ADVISORY
BULLETIN

No. 2001-09
(Mercury Jet Drives No. 2001-01)

Official Recall Notification Federal Boat Safety Act Voltage Regulator – 240 HP Jet Drive

240HP JET DRIVES – 2000/2001 Model year product

- a** - Voltage Regulators
- b** - Fuse Holder

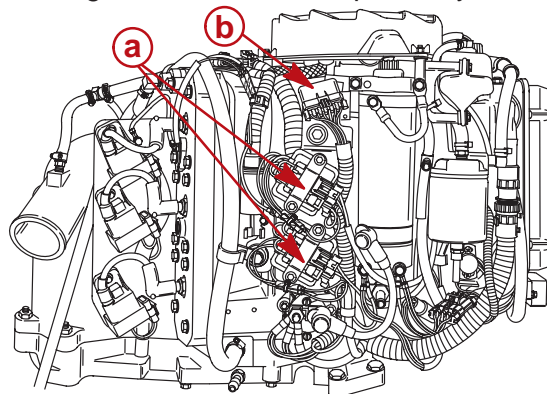
Voltage regulators that are in use on products identified above are at risk of experiencing an electrical short. A short, if it occurs, could be an ignition source for any flammable material in close proximity to the voltage regulator.

In November of 2000, a field campaign was initiated for all 240HP Jet Drives with the serial numbers 0E370718 through 0E394131. The campaign required the replacement of the voltage regulators. However, Mercury Marine has recently learned that the potential for a short, although very remote, still exists in the replacement voltage regulators. This risk can be eliminated by increasing the rating of the fuses from 20A to 30A.

- All 240HP Jet Drives that did not respond to the original field campaign will require both the regulators and fuses replaced (serial number 0E370718 – 0E394131).
- All 240HP Jet Drives that did respond to the original field campaign and those with serial numbers 0E394132 through 0E397308 will require only the fuses replaced.

Mercury Marine will replace the regulators and/or fuses on the affected 240HP Jet Drives as described below.

a - Location of Dot

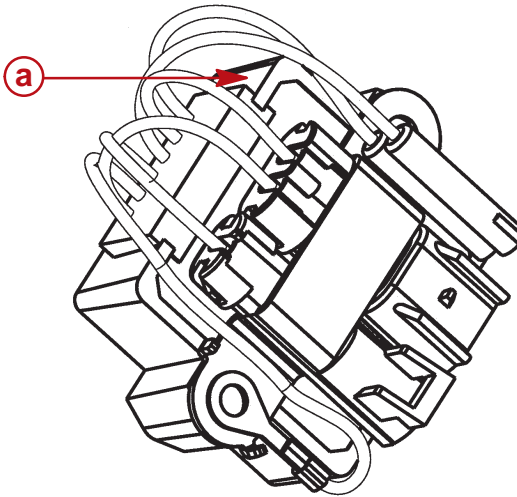
All boats in inventory (new or used) with 240HP Jet Drives that fall in the affected serial number range should be checked. Inspect the regulators for either a “Green” or “White” dot and/or part number (883072-1) stamped on them. Painted dots are located next to the wires exiting the regulator. The part number is located on the opposite side of where the wires exit the regulator. Also, check the fuses. If they are 20A fuses, replace with 30A as shown below.
